POWERHOUSE PARRAMATTA
**DESIGN
INTEGRITY
REPORT**

Museum of
Applied Arts
& Sciences

This report outlines the design integrity process and review that has occurred to support a modification application for Powerhouse Parramatta SSD-10416 for amendment of the pavilion roof and fit out and use of St George's Terrace.

Figure 1.
Modified roof top design

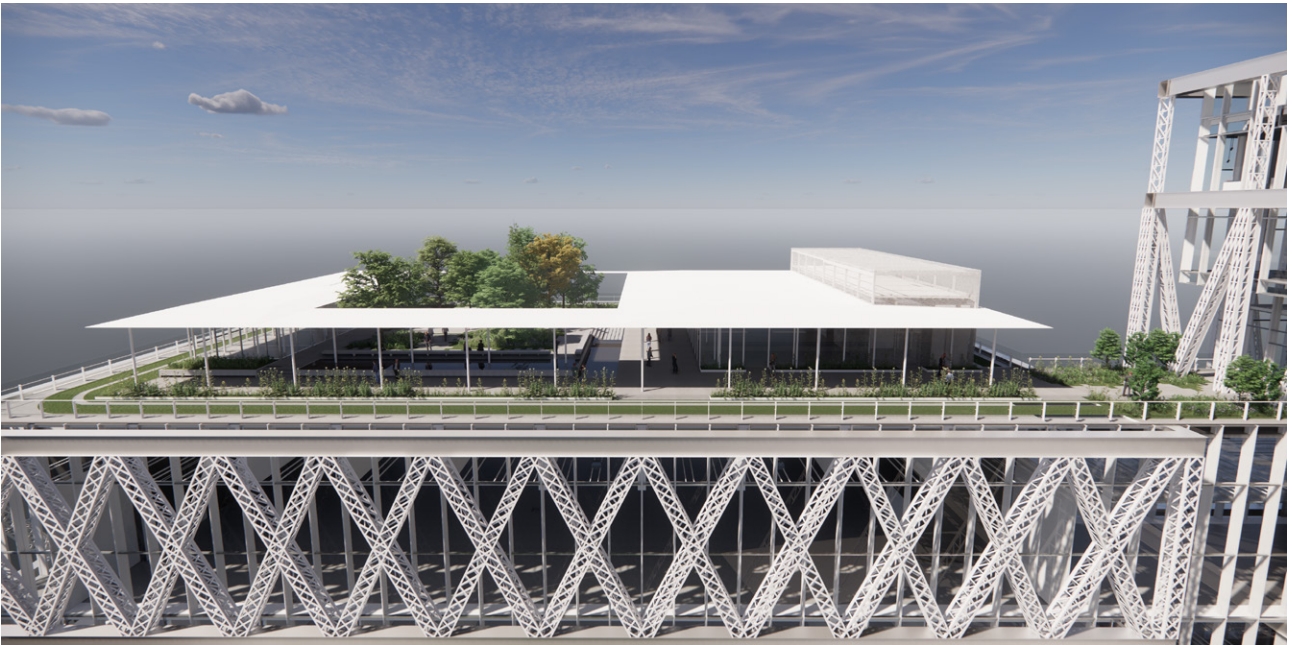
The Panel has reviewed the proposed design for the expanded pavilion and notes that:

- The structure remains well below the permissible height limit;
- The increase of the pavilion will enable it to service a wider array of functions;
- The expanded roof structure is light-weight and minimal in design and in-keeping with the remainder of the building; and
- The proposal represents a considered development of the design.
